# FINAL ENVIRONMENTAL IMPACT REPORT

## Santa Cruz Wharf Master Plan

[SCH NO: 2016032038]

**City of Santa Cruz**  
**Economic Development**

### BIO-1c Effects on Wildlife Populations

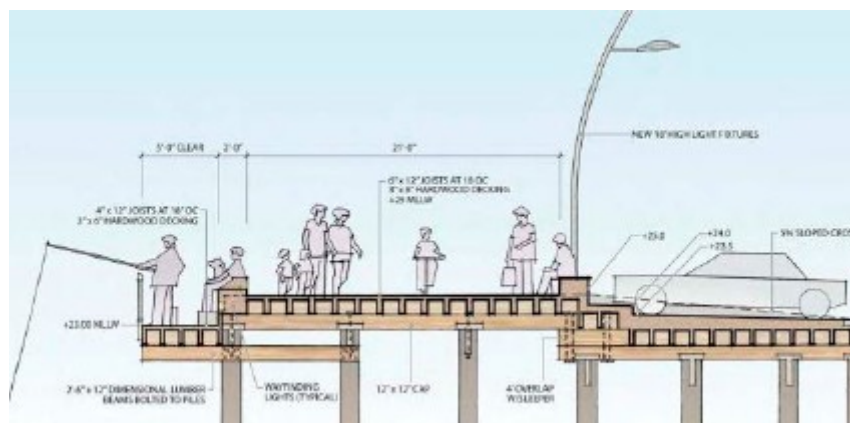
Of concern is the statement that the “Master Plan includes a new boat landing for research and visitor vessels. At this time it is not known when this facility may be developed”. Based upon this temporal ambiguity, the DEIR then appears to brush off any concerns related to increased boat traffic. As it is not known when all aspects of this plan may be developed, the statement referred to above is inappropriate. Should the Wharf, for example, seek to host tenders from cruise ships in the future, impacts from this new boat landing may indeed be significant. We request that a proposed, stated, level of boat traffic be included for this analysis, and that any increase above that level be required to trigger new environmental review. With the proposed use of this boat landing for 200 ton displacement vessels, the DEIR should include analysis of the impacts on wildlife of this use, done by qualified personnel.

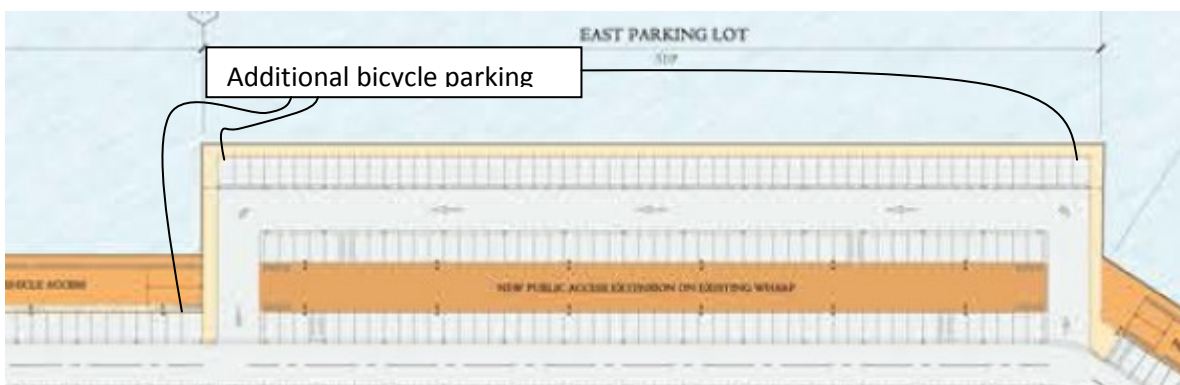
The Sierra Club appreciates and applauds the proposed design for its large bicycle and pedestrian walkway, as seen here:

This can give the impression that the Plan takes bicycle transportation seriously. Access is only a portion of visiting the Wharf by bicycle. The design fails to provide adequate bicycle parking. City of Santa Cruz Ordinance No. 2017-02 requires that public or commercial recreation uses have a number of parking spaces of at least 35% of the auto parking spaces. The design calls for 64 bicycle parking spaces yet 495 auto parking spaces – 12.9%. Although mention is made of providing more spaces in the future, how and where these spaces will be is of concern. Namely, whereas all of the auto parking spaces are designed in and indicated, the future bicycle spaces are not, and then evidently must be taken from areas already identified for pedestrian and bicycle use. A Plan without the full amount of required spaces is in conflict with the City requirements; but even if it were not the proposed 64 spaces indicates that bicycle parking is an afterthought in this Plan. We strongly recommend that all corner areas currently designated for auto parking be instead allocated for bicycle parking, so that proper accommodation of bicycles may be achieved:
